Access Compliance Report Public Rights-of-Way (Curb Ramps)

Main Street: **BROWNING_AVE** Cross Street: **LA_COLINA_DR** Location: **SE**

ADA ID: **RPRK211014133803** Ramp Type: **Type 4 - Parallel** Initial Pass/Fail: **Fail** Overall Compliance: **No** Severity Score: **15**

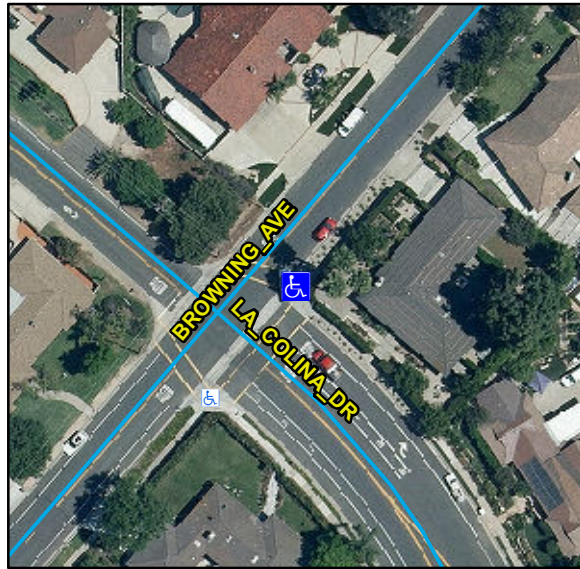
Compliance	Description	Data	Compliance	Description	Data
N/A	Ramp Length LT (in)	98	N/A	Ramp Length RT (in)	123
Yes	Ramp Width LT (in)	78	Yes	Ramp Width RT (in)	52
No	Ramp Run Slope LT (%)	8.4	Yes	Ramp Run Slope RT (%)	8.3
Yes	Ramp Cross Slope LT (%)	1.1	Yes	Ramp Cross Slope RT (%)	1.3
N/A	Landing Present	N/A	N/A	DWS Provided	N/A
N/A	Landing Length (in)	N/A	N/A	DWS Contrast	N/A
N/A	Landing Width (in)	N/A	N/A	DWS Length (in)	N/A
N/A	Landing Run Slope (%)	N/A	N/A	DWS Full Width	N/A
N/A	Landing Cross Slope (%)	N/A		DWS Offset Type	N/A
N/A	Landing Movement Obstructed?	N/A	N/A	DWS Offset Left (in)	N/A
	Landing Movement Type	N/A	N/A	DWS Offset Right (in)	N/A
N/A	Landing Shared	N/A			
N/A	Clear Space	Yes			
N/A	Clear Space To Crosswalk (in)	48			
N/A	Marked Crosswalk 1	Yes	N/A	Marked Crosswalk 2	Yes
	Crossing 1 Direction	NW		Crossing 2 Direction	SW
	Marked Crosswalk 1 Width (in)	144		Marked Crosswalk 2 Width (in)	144

Remove & Replace Curb Ramp With Two New Directional Ramps or Equivalent.
